# Sutton to Colliers Wood Cycleway (St Helier area)

## Get Sutton Cycling response to the informal consultation | October 2019

*This response to the [Cycleway between Sutton High Street and Colliers Wood - proposals in the St Helier area](#) informal public consultation (9 October 2019 to 4 November 2019) has been prepared by Charles Martin on behalf of Get Sutton Cycling. Get Sutton Cycling represents the **London Cycling Campaign** in Sutton.*

**Figure 4: Plan of proposed signalised crossing for Bishopsford Road (LB of Sutton)**

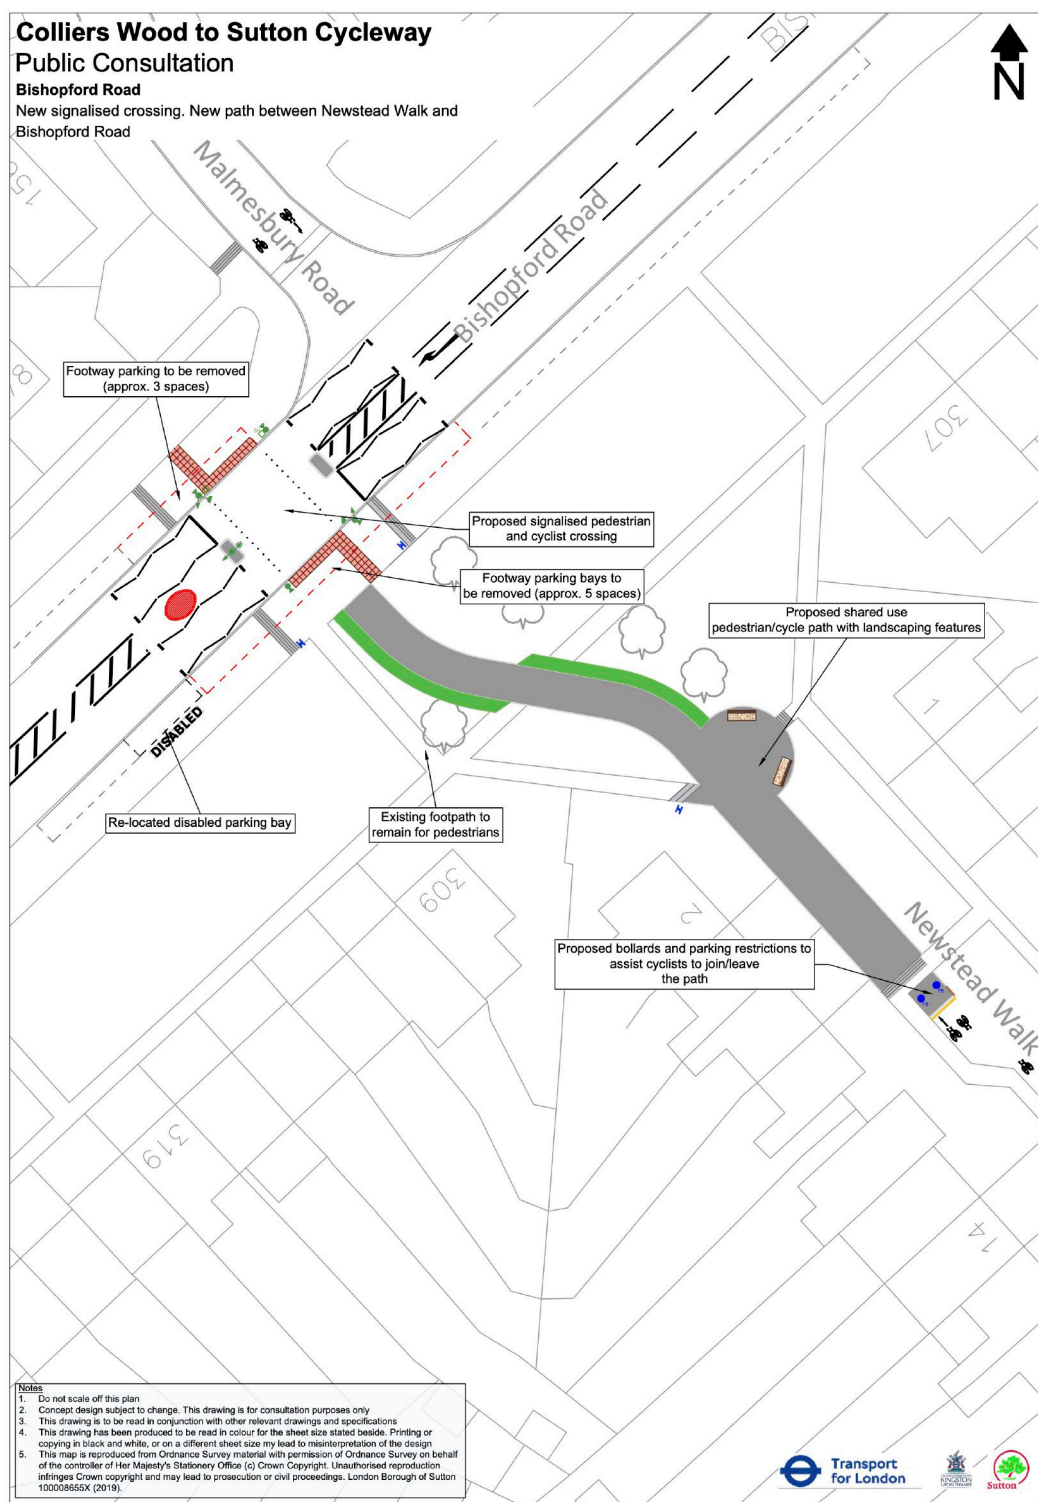
**However, the proposed design** of the new signalised, shared pedestrian and cycle crossing at this location (Figure 4) **appears to have several limitations**, including the potential to create conflict between cyclists and pedestrians. At the very least, there would be the expectation for this signalised crossing to be a parallel cycle and pedestrian crossing (rather than the proposed shared crossing) on a full-width raised table<sup>6</sup>. **A much better, and preferred, option would be for the construction of a signalised stand-alone cycle crossing on a direct alignment between Newstead Walk and Malmesbury Road.**

Limitations of the proposed crossing design include vulnerability for those on foot, who will be required to mix with cyclists on a section of footway on the west side of the crossing, as well as on the crossing itself; vulnerability for those cycling southbound on Malmesbury Road to access the crossing due to the potential conflict with motorists turning on to Malmesbury Road from Bishopsford Road; vulnerability for cyclists and pedestrians when riders, who are cycling on Bishopsford Road (north or south), wish to join the new path to Newstead Walk but find their access blocked by people waiting to cross the road. This latter situation could create a particularly dangerous situation for a rider, because the circumstance could result in them needing to perform an emergency stop on road carry large volumes of fast moving traffic in a constrained-width carriageway.

Therefore, **the preferable option would be for the Newstead Walk path** (possibly as a 'walking and cycling link' (Figure 6)) **to be routed so that it aligned directly with Malmesbury Road**, and for **Malmesbury Road to be closed to motor traffic at its intersection with Bishopsford Road (but to include a gap for cycling)**, and for **a signal-controlled crossing to be constructed between the newly aligned Newstead Walk and the filtered entrance to Malmesbury Road**. All conflict would be removed, and a robust, highly visible, cycling asset would be created.

**Ideally, the scheme design for the Bishopsford Road crossing would additionally incorporate sections of segregated paths along Bishopsford Road to future-proof the**

- **As a minimum requirement, provide a parallel pedestrian / cycle crossing on Bishopsford Road on a full-width raised table**
- **Consider the introduction of a signalised stand-alone crossing on Bishopsford Road to be directly aligned between Newstead Walk and Malmesbury Road, and for this to include a point closure, with cycle gap, at the point of entry with Malmesbury Road**
- **Ensure the final design of the crossing at Bishopsford Road facilitates ease of manoeuvre in all directions by all types of cycle**

**Figure 5:** Plan of proposed parallel crossing for Wrythe Lane (LB of Sutton)

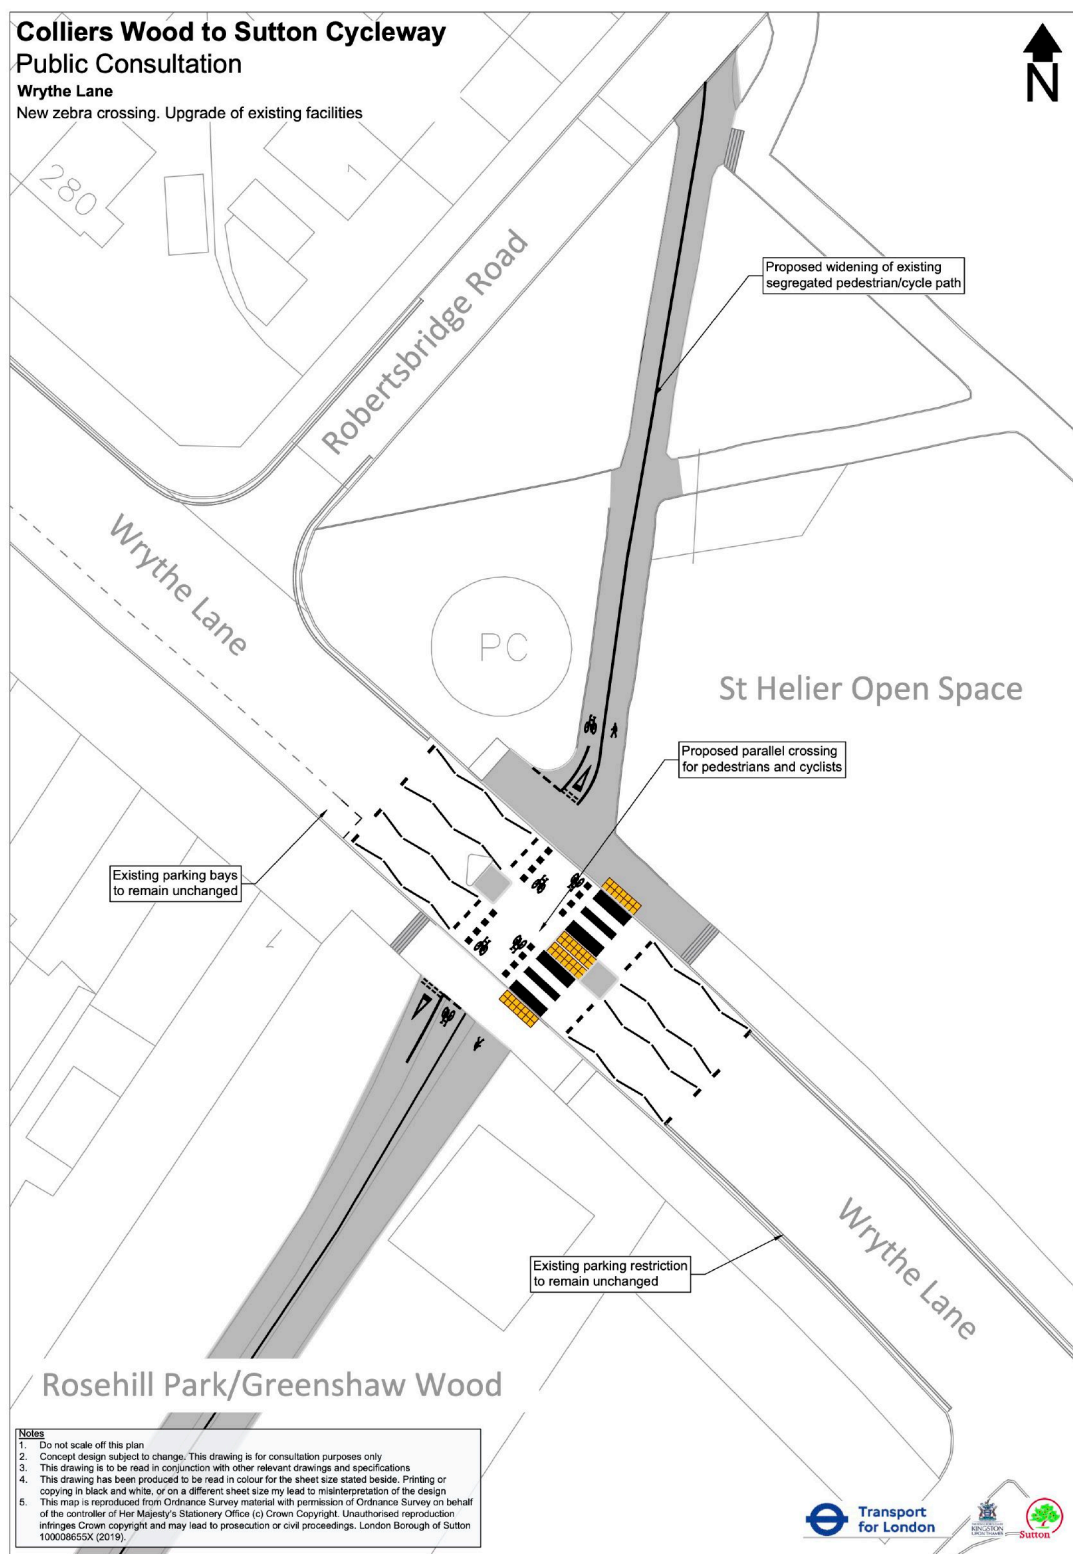
The proposal to widen the path between Robertsbridge Road and Wrythe Lane (Figure 5) is supported, but a **key consideration is that the path is constructed to a high standard** to provide a surface that is smooth, non-undulating, and has good rolling resistance. The path needs to remain free of standing water in wet weather and free of ice in cold weather.

The 'not sure' option has been selected in response to support for this proposal because there is an element of ambiguity in the question as posed. The path as currently installed between Robertsbridge Road and Wrythe Lane is not shared use, as implied in the question, but provides partial separation<sup>8</sup>, as noted in the accompanying plan.

It is our view that **retention of the existing partial separation** (essentially a segregated pedestrian/cycle path as currently the case) **remains the preferred option over shared use**. One reason for this is because separate paths will **provide a better interface with the proposed parallel zebra and cycle crossing** at Wrythe Lane, and reduce conflict between users. A full 'walking and cycling link' design (Figure 6), whereby a cycle carriageway is flanked by footways, **would be the most desirable option** as this would be fully adaptable for future growth in cycling.

A new zebra crossing with a parallel crossing for cyclists across Wrythe Lane (Figure 5) is strongly supported. The parallel crossing will have the additional benefit of facilitating a wider aperture to the paths either side of Wrythe Lane. **An improvement on the proposed design would be for the crossing to be on a full-width raised table, and for the central refuge island to be removed.** There is a concern that the depth of the central pedestrian refuge island may not be of a sufficient enough size to accommodate cycles with extensions when they are stationary and awaiting to cross the second carriageway. With the raised table in place, it would be appropriate to extend the 20 mph speed limit along Wrythe Lane (at least over the section of the road passing by the hospital and the shopping area - Thornton Road to Rose Hill).

An ongoing issue with the existing crossing point, and its interface with the adjacent paths, has been the poor facilitation of access by cycle to the Rosehill Park path when approached from the westbound direction on Wrythe Lane. (This was discussed in our report of a [cycle tour of St Helier](#) that took place in August 2015). **The new design for the crossing and path will need to ensure that all manoeuvres between all directions can be comfortably made with ease by all styles of cycle.**

- **Ensure the Robertsbridge to Wrythe Lane path is constructed to a high standard**
- **As a minimum requirement, retain partial separation on the Robertsbridge to Wrythe Lane path**
- **Consider the option of converting the Robertsbridge to Wrythe Lane path to a 'walking and cycling link' (Figure 6)**

- **Include a full-width raised table as part of the final design of the Wrythe Lane parallel pedestrian/cycle crossing**
- **Ensure that the final design of the Wrythe Lane crossing facilitates ease of manoeuvre in all directions by all types of cycle**
- **Consider the scope for integrating with the Cycleway plans ideas for introducing segregated cycle lanes on Wrythe Lane at some future point**

**Figure 7:** Plan of proposed upgrade to the existing segregated pedestrian/cycle path linking Wrythe Lane with Rosehill Park West and Grennell Road (LB of Sutton)

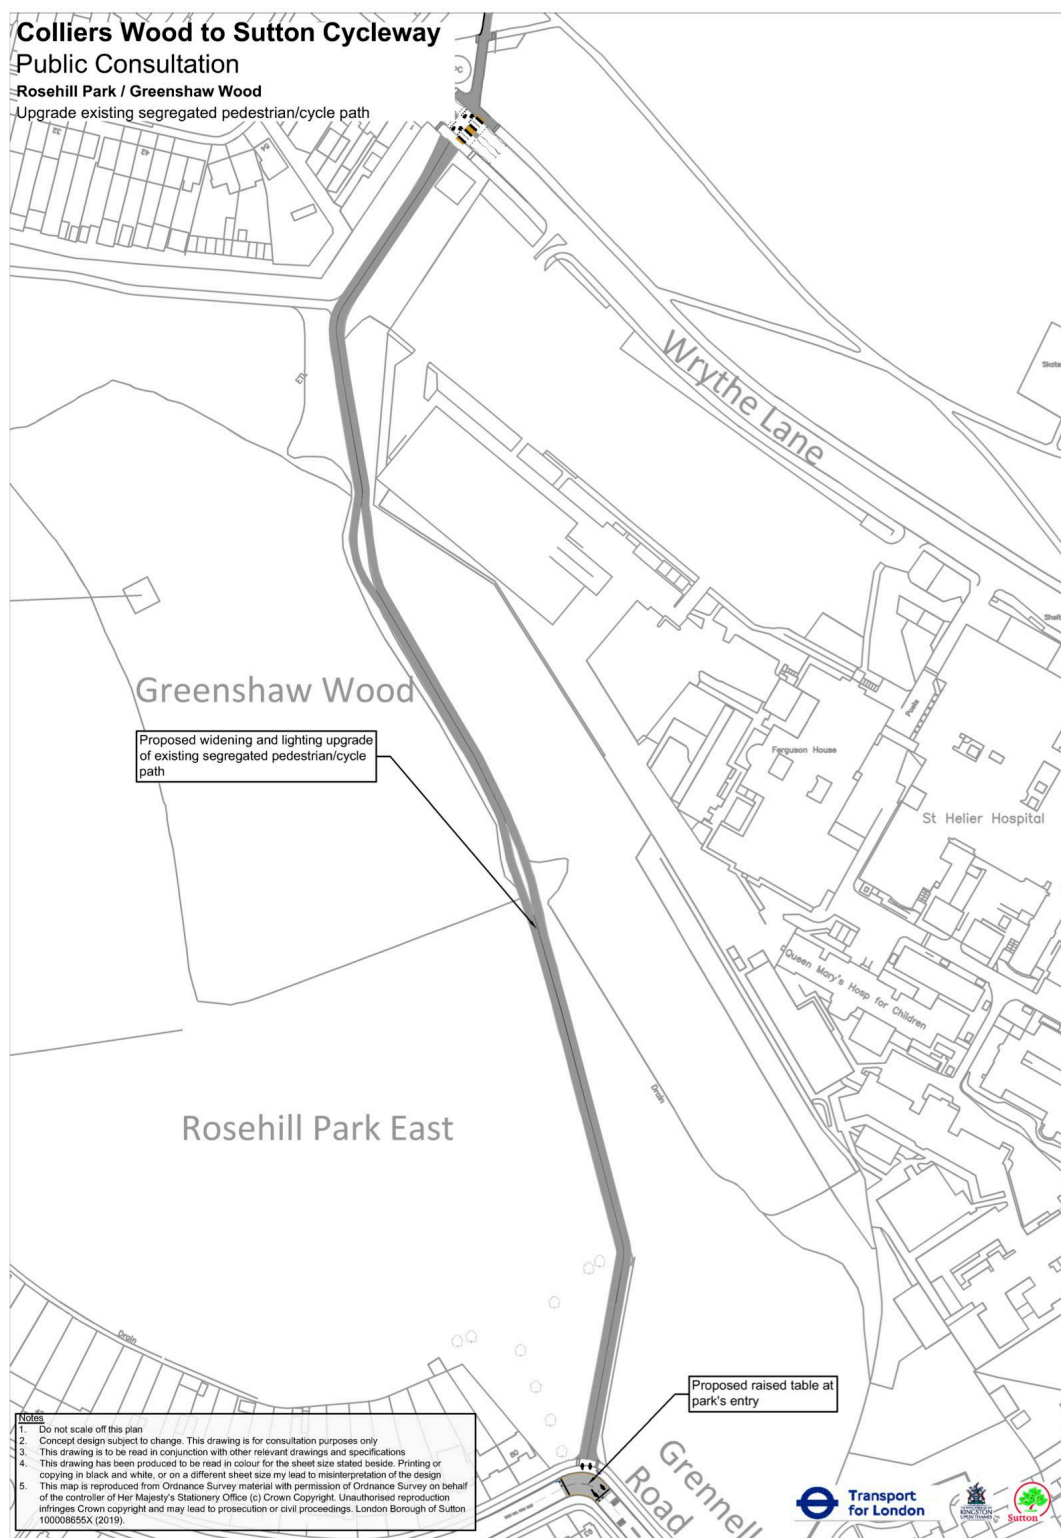
The 'not sure' option has been selected in response to our support for the proposal to widen the path through Greenshaw Woods between Wrythe Lane and Grennell Road (Figure 7) because there is an element of ambiguity in the question as posed. The link, as currently installed between Wrythe Lane and Grennell Road, is not shared use as implied in the question, but provides partial separation (a segregated pedestrian/cycle path) as noted in the accompanying plan (Figure 7). It would be anticipated that separation between those cycling, or using mobility scooters, and those on foot is maintained (or improved upon). The proposal to widen the path would suggest that partial separation is to be maintained, as the over-all width requirement is greater for partially separated paths<sup>10</sup>.

**Maintaining partial separation would ensure that the path is future-proofed for anticipated growth in cycling.** Furthermore, a study to understand cycling among the older population, and how this affected independence, health and wellbeing<sup>11</sup>, has shown that this cohort in particular feel more comfortable cycling when not having to share space with people on foot. The London Cycling Design Standards (2014)<sup>12</sup> notes "...people with visual impairments, children and older people, all of whom may feel intimidated by sharing space with cyclists". **The new Cycleways are designed to attract older people and children**, and so this is another reason for maintaining a separation. The LCDS also notes<sup>13</sup> "The **proximity of schools** [in this case Greenshaw High School], residential accommodation for older people, **hospitals** [in this case St Helier Hospital], health centres and facilities for disabled people **can have a significant influence on the composition of pedestrian flows. It may highlight the need for cycle-slowness measures or even rethinking cycle routes to avoid the need for shared use**". A 'walking and cycling link' design may be considered less appropriate here as it would be important not to urbanise the green space. Nevertheless, provided careful considerations for the unique surroundings of Greenshaw Woods and Rosehill Park East open space were upheld, the 'walking and cycling links' option could be worthy of consideration.

As noted in previous sections, the key consideration for the path is that it is constructed to a high standard to provide a surface that is smooth, non-undulating, and has good rolling resistance and remains free of standing water in wet weather and free of ice in cold weather.

Additionally, **the construction of a new path, as a spur, between the proposed, upgraded, Greenshaw Woods path and St Helier Hospital, would be highly recommended.** After all, it is highly likely that the demand for cycling between Sutton town centre or surrounding residential areas and St Helier Hospital is higher than the demand for cycling between Sutton town centre and Colliers Wood (although evidence to the contrary would be welcome). It is recognised that a spur path would require the construction of a new entrance through the perimeter fence, along with changes to the hospital car-park layout. Alternatively, a better option would be to facilitate segregated cycle lanes on Wrythe Lane, and so provide access to the front entrance of the hospital directly linked to the Cycleway.

The existing kerb-side gully, at the intersection of Grennell Road/Rosehill Park West and the Greenshaw Woods cycle path, causes a significant undulation for riders crossing between the road and the path (and vice versa). The discomfort is further heightened by the angle of entry and exit (required to provide improved visibility). A raised table built over the drainage gully would facilitate a greatly improvement here.

- **As a minimum requirement, retain partial separation between the paths linking Wrythe Lane with Grennell Road**
- **Ensure the Wrythe Lane to Grennell Road link is constructed to a high standard**
- **Consider the scope for new techniques in lighting provision on the Wrythe Lane to Grennell Road link that is in harmony with the surroundings**
- **Consider the options for constructing a direct walking and cycling link to St Helier Hospital (not to preclude the preferred option for segregated paths along Wrythe Lane at some future point)**

- **Ensure the interface at the point at which the Wrythe Lane to Grennell Road path joins Rose Hill Park West / Grennell Road is constructed to a high standard and provides safer geometry than is currently the case, with minimum variation in surface level between the path and the carriageway**
